Subject: Re: SS FRONT COOKING SELF EXHAUST SYSTEM

We kindly request you to review the attached alternate model for the equipment listed below and provide your approval at the earliest so we can proceed accordingly.

| OUTLET NAME | ITEM NAME | Dimension | Brand |
|-------------------|--|------------------------|--------------|
| MUM JOSH T2 CSMIA | SS FRONT COOKING UNIT SELF EXHAUST SYSTEM WITH INDUCTION & FRYEI | R 1410 x 750 x 1350Ht. | SSS-S-KMU-2E |

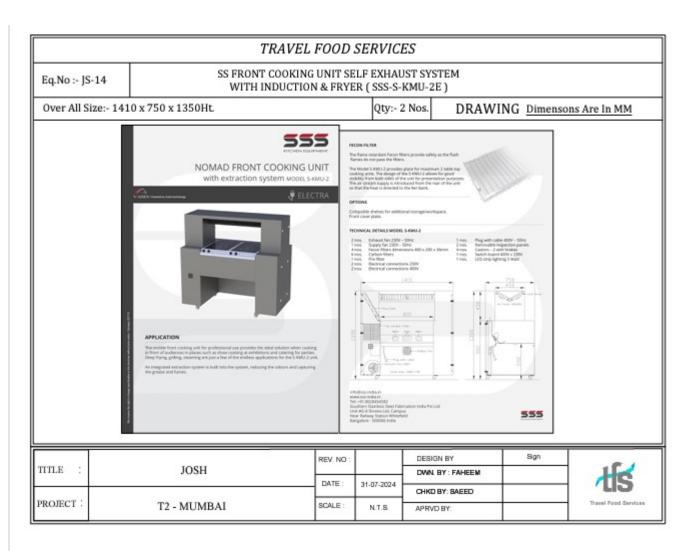
Below are the Equipment we are placing above the Self exhaust Unit, will require the electrical points to be incorporated in the unit itself. Also will require the electrical requirement accordingly.

Unit 1. - Fryer - 3.2Kw. & Induction WOK - 5Kw. (32amp Metal Clad).

Unit 2. - Hot plate - 4.4Kw.

Kindly make provisions for this Equipment in unit and share the requirement of self exhust unit to make provision at site.

Please share the electrical requirement for the equipment and also the Electrical points available in the equipment.

Dimension wise equipment is good to go, require Electrical specs for the same to confirm.

Thanks for the update, We will provide 3phase plug for the unit.

As per the confirmation, we can proceed with the procurement for the same.

we will put the sockets required as per your equipment you are going to place.

It is a plug and play system. Hence we need one 3 Ph-plug for the power coming into the unit. The power is internally distributed for running the blower of the system and for the sockets used for plugging into the table top equipment.
